COMPTROLLER GENERAL OF THE UNITED STATES
WASHINGTON, D.C. 20548

B-177148

In response to your requests of September 26, 1972, and January 24, 1973, and discussions with your office, we examined the contract award for constructing a public housing project (ILL.-18-6) for the elderly in Rock Island, Illinois. The Department of Housing and Urban Development (HUD) is financing the project under its low-rent housing program.

COMMENTS ON QUESTIONS RAISED BY MAIWALD-BENSON
AND ASSOCIATES AND DISCUSSION OF HUD'S
REASONS FOR NOT SELECTING THE WATERS CONSTRUCTION
COMPANY AS THE PROJECT DEVELOPER

Waters Construction Company

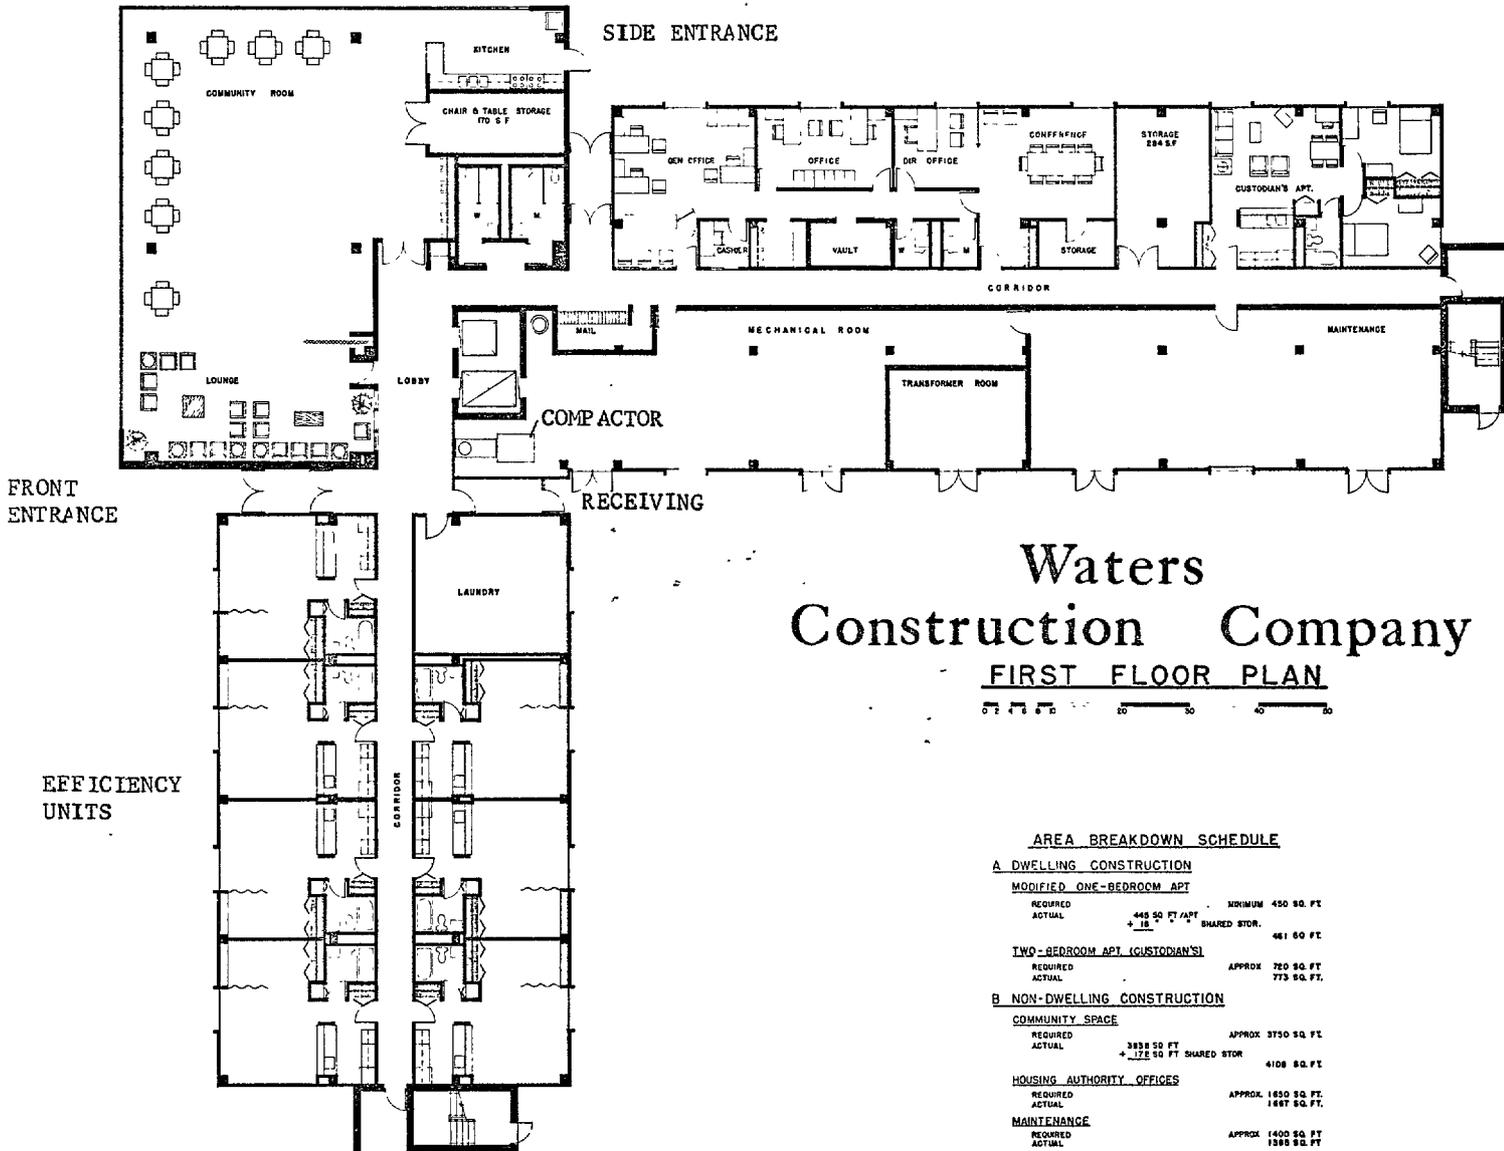
"Building has too many entrances for efficient traffic control and building function."

Mr. Sich said the Waters proposal provided for two main entrances--a vehicular traffic entrance and a side entrance adjacent to the general offices. According to Mr. Sich, the traffic entrance could not be observed from the general offices and traffic control would be poor. (See exhibit A.)

"Receiving, trash and Mechanical Rooms are combined. This is not acceptable."

HUD Minimum Property Standards provide that trash rooms be enclosed and separated from the rest of the building. The Waters proposal provided for a trash compactor in an unenclosed room which was not separated from the rest of the building. (See exhibit A.)

"Dwelling units are located on the first floor. This is direct non-compliance with the LHA advertisement."

The authority's invitation to bid stated that "One Hundred Ninety-nine (199) units shall be modified one-bedroom, minimum 450 square feet, located above the first floor." (Underscoring supplied.) Contrary to this requirement, the Waters proposal provided for seven efficiency units on the first floor.

"Tenant Lounge is part of main community room. This is not acceptable."

According to Mr. Sich, the lounge and community room serve two different functions and, therefore, should be permanently separated. He explained that the lounge is used as a waiting area and the community room is used for group meetings and activities. The Waters proposal provided for the lounge and community room to be separated by a soundproof folding wall.

"Community kitchen is poorly located in relation to the community room to be able to provide efficient and uninterrupted service."

Mr. Sich said the most desirable location for a kitchen would be near the center of the community room rather than in a far corner, as outlined in the Waters proposal. He explained that in this proposal the entrance to the kitchen from inside the building could be reached only by passing through the community room. He believed that community room functions in process might be interrupted as a result of this traffic pattern.

**COM-FAM CORPORATION
FIRST FLOOR PLAN**

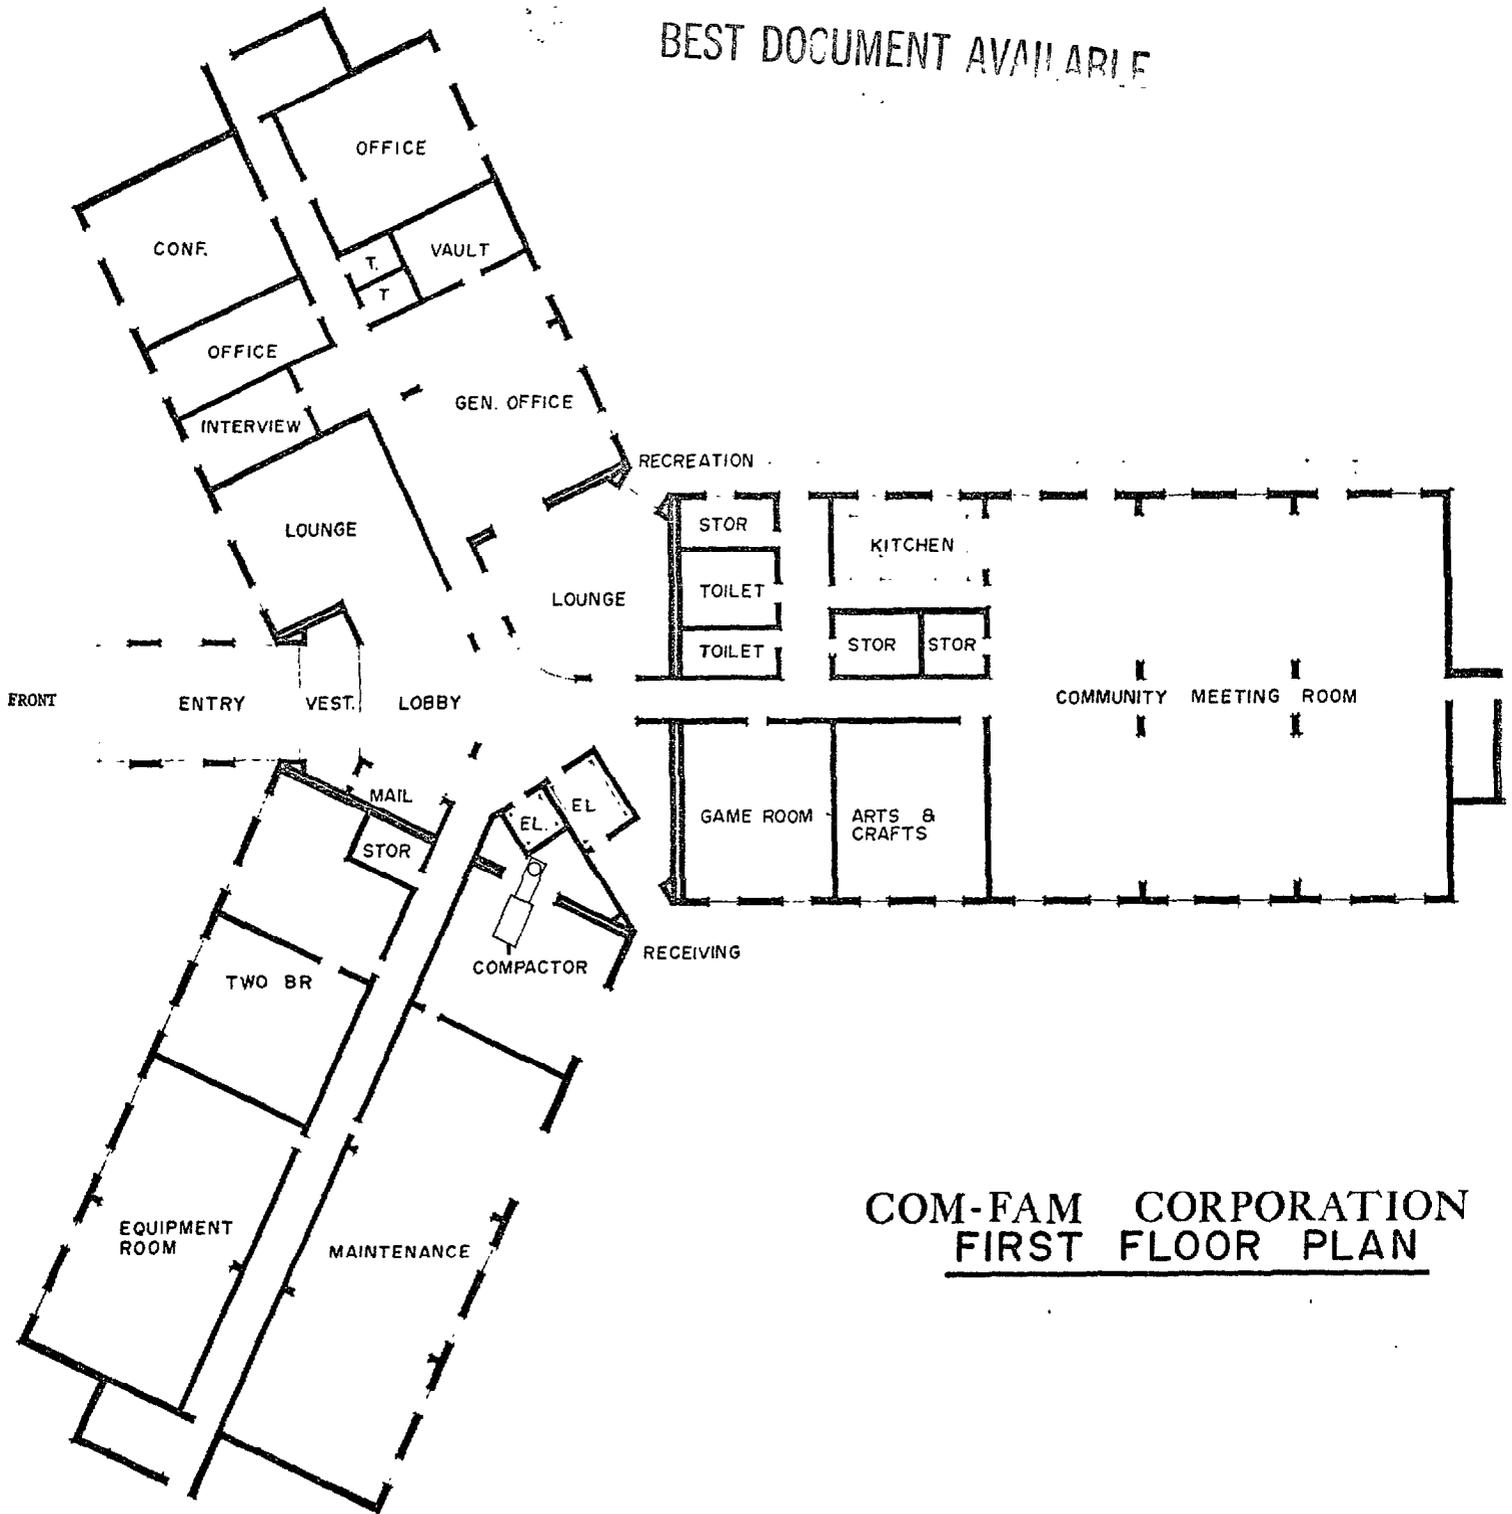
Mr. Sich told us that rough sketches of the building and unit plans, as provided by Com-Fam, were adequate during the proposal stage.
